Air Quality Impact Modeling Protocol – Construction Class I SIL and Visibility

Outer Continental Shelf Permit

Revolution Wind Farm

VERSION 2

Figure A-3
Class I Receptors
Revolution Wind

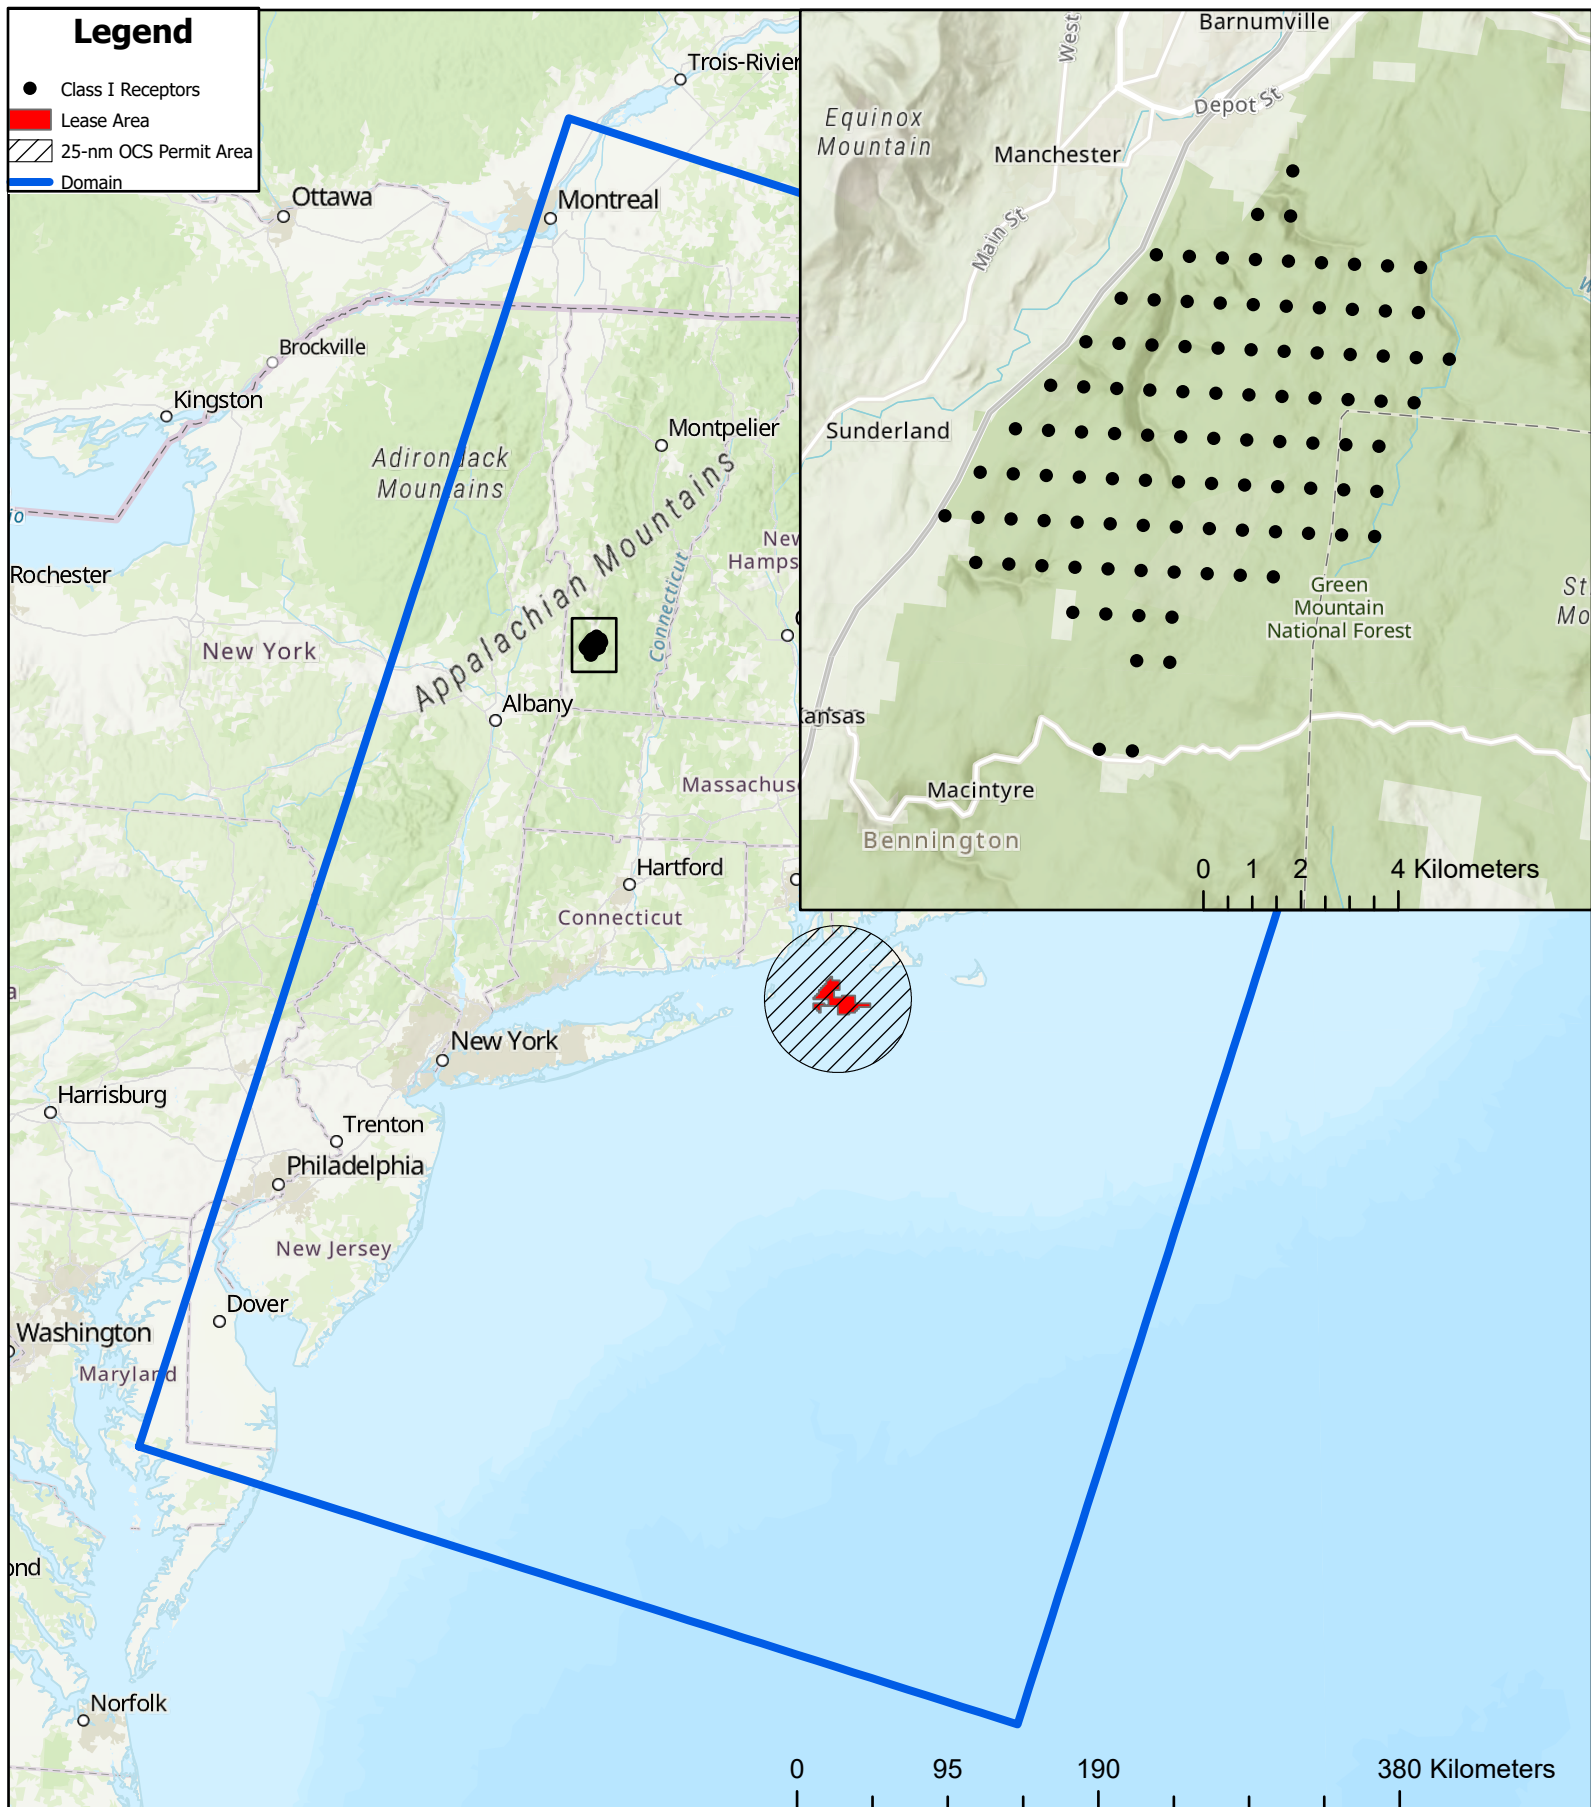
- EPA recommends that a figure be added to show the CALPUFF modeling domain including the locations of the Revolution Wind Farm and the Lye Brook Wilderness area receptors.

4. Section 4.8. *EPA recommends that a figure be added to show the CALPUFF modeling domain including the locations of the Revolution Wind Farm and the Lye Brook Wilderness area receptors.*

Figure A-3 has been revised to include the boundary of the CALPUFF model domain which matches that of the MMIF domain used to produce the WRF meteorological data outputs provided by EPA.
